SUBJECT: OPERATION OF ANO-2 DURING CYCLE 2

The Commission has issued the enclosed Amendment No. 24 to Facility Operating License No. NPF-6 for the Arkansas Nuclear One - Unit 2 plant. This amendment consists of changes to the license in accordance with the satisfactory completion of certain conditions to the license. It also consists of changes to the Technical Specifications in accordance with your Cycle 2 Reload Report and request dated February 20 and March 5, 1981 as supplemented by information identified in the Reference Section of the attached Safety Evaluation.

This amendment authorizes Cycle 2 operation subject to the condition in the license which temporarily restricts operation of the facility to seventy percent of the licensed full power level of 2815 Mwt pending completion of the staff's review of the core protection calculator system, and with the following changes.

FIGURE 3.1-2
CEA Insertion Limits vs THERMAL POWER

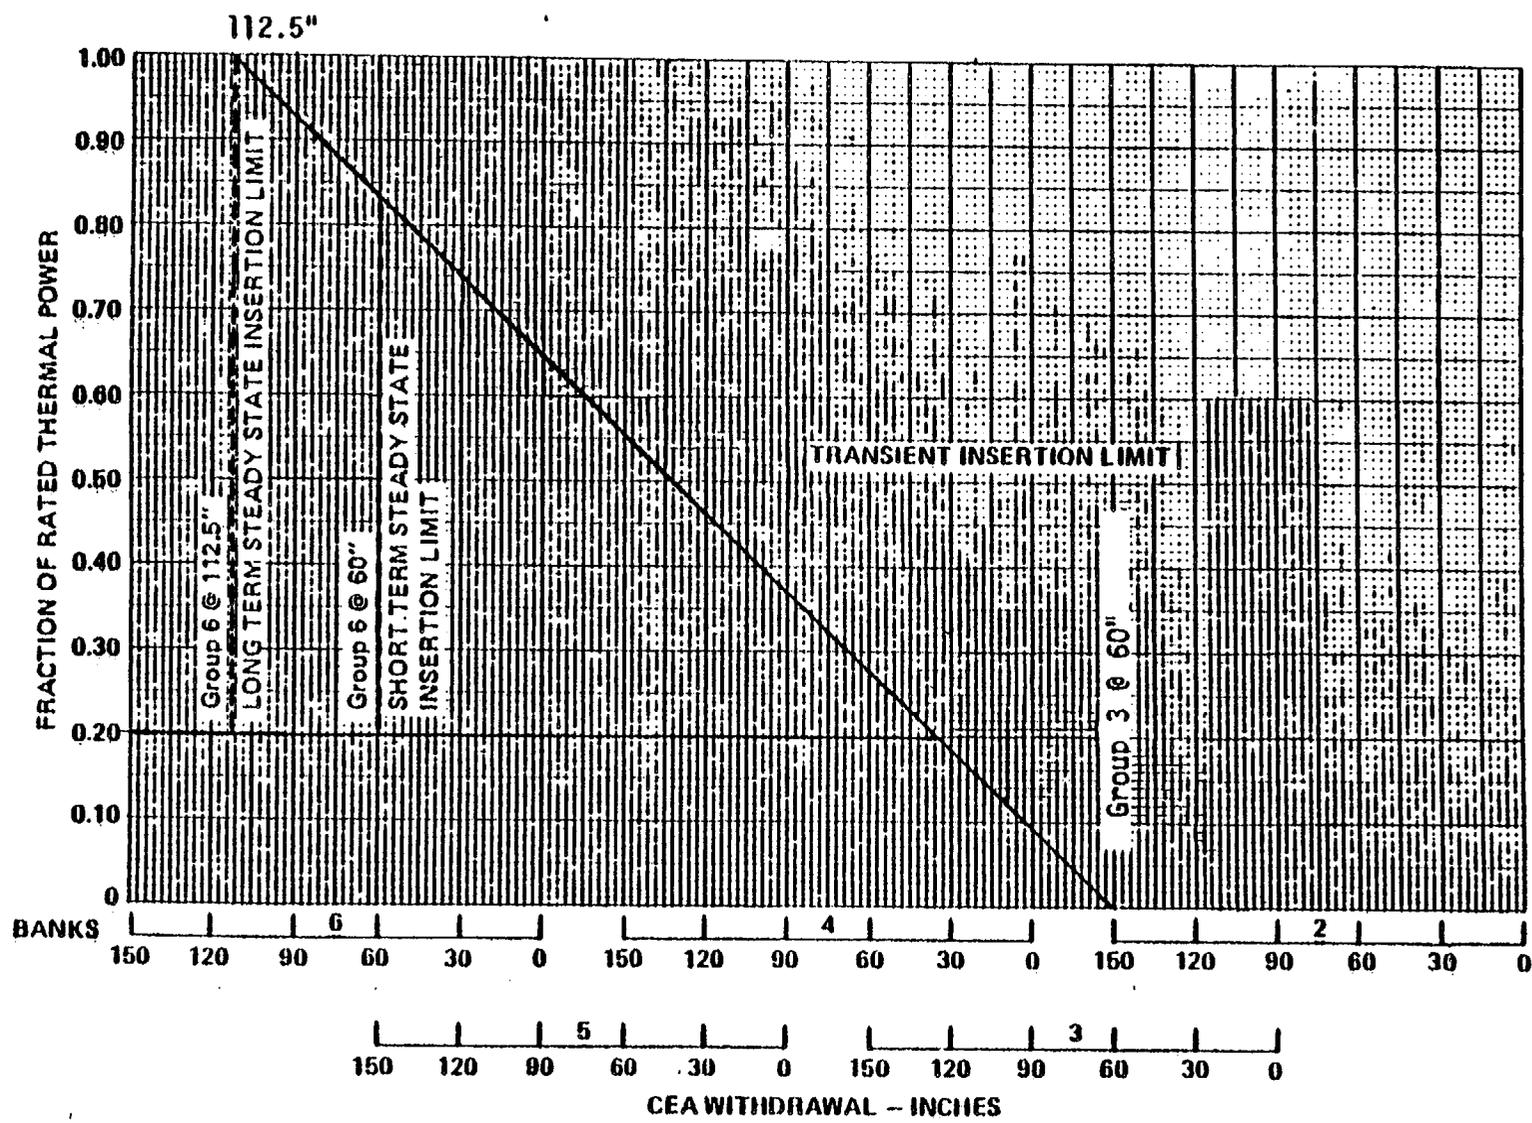
TS Figure 3.1-2 has been changed to reflect the provision of adequate shutdown margin for MODES 1 and 2. The acceptability of the shutdown margin is discussed in Section 2.2.1 of this report. The affected page is 3/4 1-27.

FIGURE 3.2-4
DNBR MARGIN OPERATING LIMIT BASED ON CORE PROTECTION CALCULATORS
(COLSS OUT OF SERVICE)

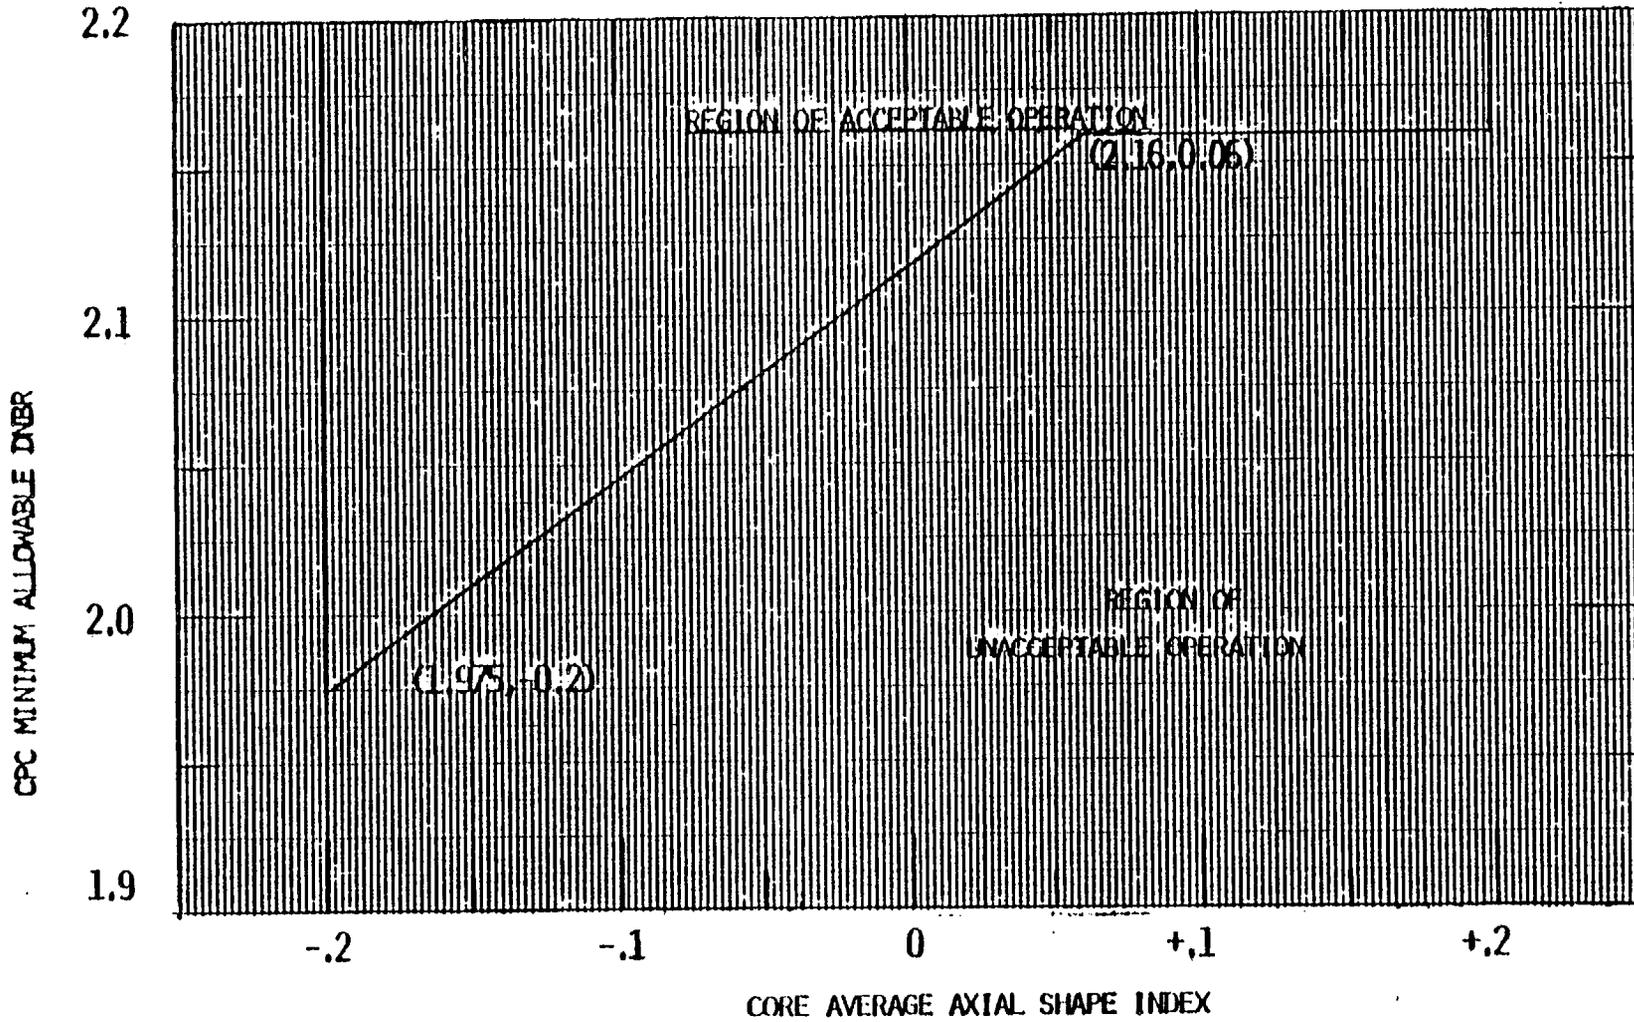
The licensee proposes to change Figure 3.2-4 due to Cycle 2 reanalysis of COLSS out-of-service DNBR margin requirements. These limits are reflected in the determination of the initial conditions for Cycle 2 anticipated operational occurrences which we have evaluated and found acceptable in Section 2.0 of this report. Therefore the proposed change is acceptable. The affected pages are: 3/4 2-7, 3/4 2-9, 3/4 2-10 and B 3/4 2-1.

Parameters required to maintain the margin to DNB and total core power are also monitored by the CPCs. Therefore, in the event that the COLSS is not being used, operation within the limits of Figure 3.2-4 can be maintained by utilizing a predetermined DNBR as a function of AXIAL SHAPE INDEX and by monitoring the CPC trip channels. The above listed uncertainty and penalty factors are also included in the CPC.

Figure 3.5-1 Containment Internal Pressure vs. Containment Average Air Temperature

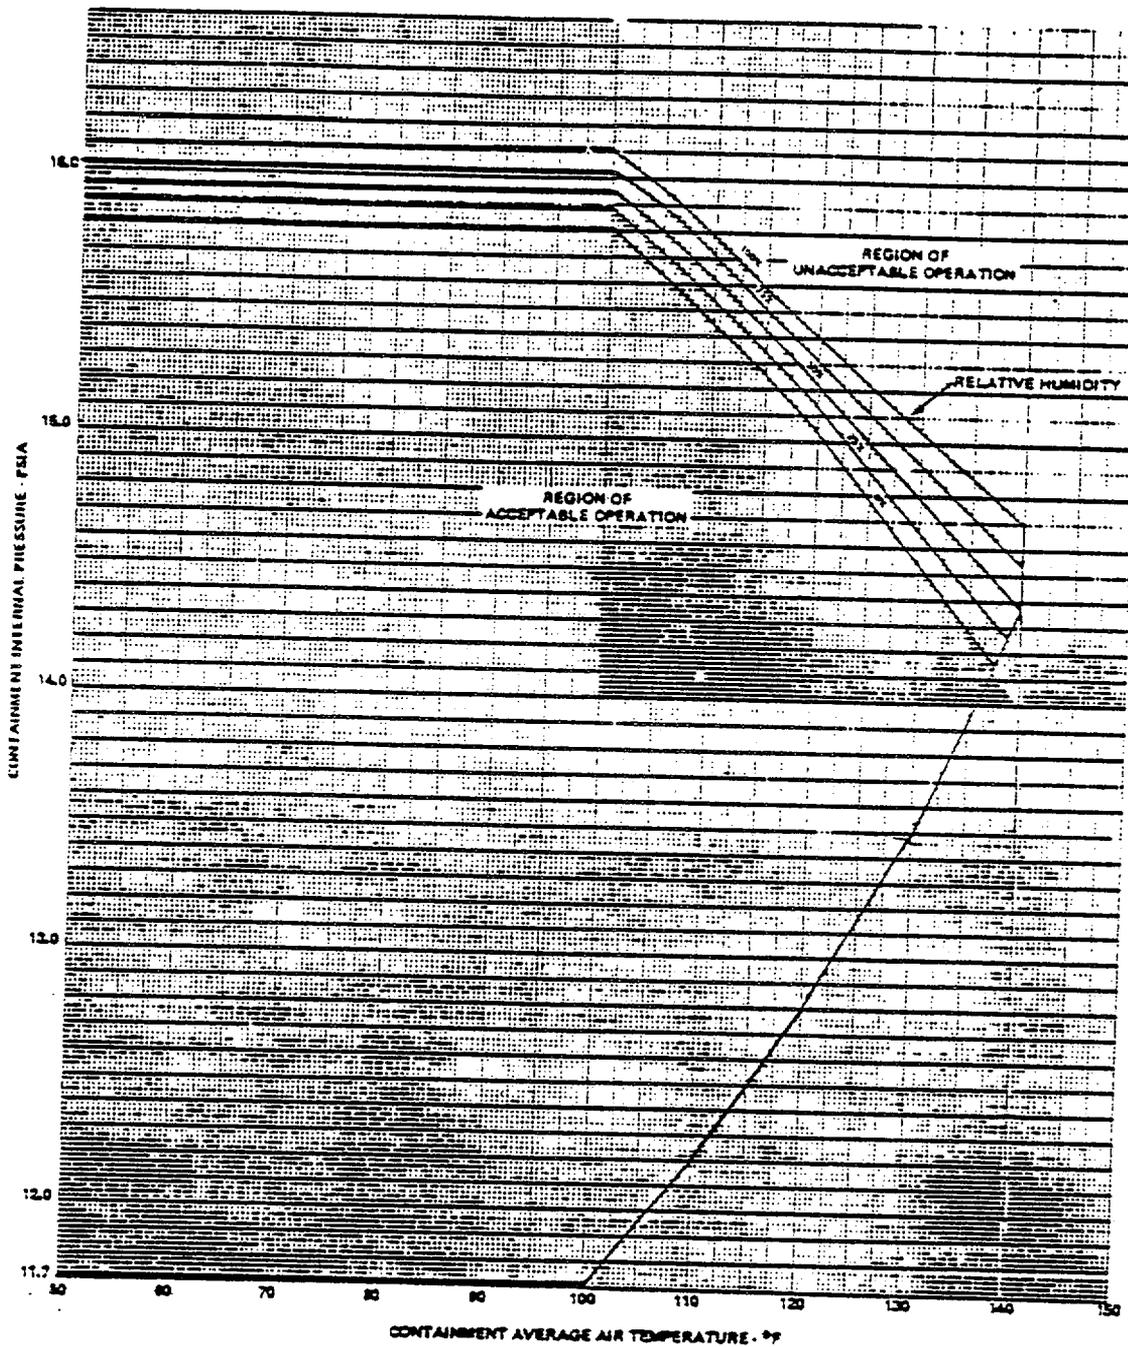
By letter dated November 19, 1979 proposed additional limits on the acceptable combinations of containment pressure and temperature to be included in TS Figure 3.6-1. The acceptability of this change is addressed in Section 2.7.1 of this change is addressed in Section 2.7.1 of this report. The affected page is 3/4 6-7.
